## Important announcement for all E-M5 camera owners

Affected Serial Number Range  
Black BEJ501001~BEJ504916  
Silver BF3501001~BF3503164

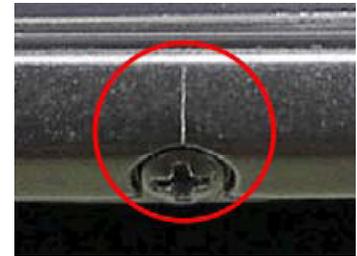
Products affected with defect will have small cracks in the Monitor cover adjacent to the Monitor cover screws at the location shown in the photo.

Inconsistent tightening of screws during the assembly process and inadequate strength of the monitor cover material.

Changes in the manufacturing methods have been adopted. This includes the addition of a washer to more evenly distribute the pressure applied by the monitor cover screws.

The addition of a washer is made to more evenly distribute the pressure applied by the monitor cover screws.
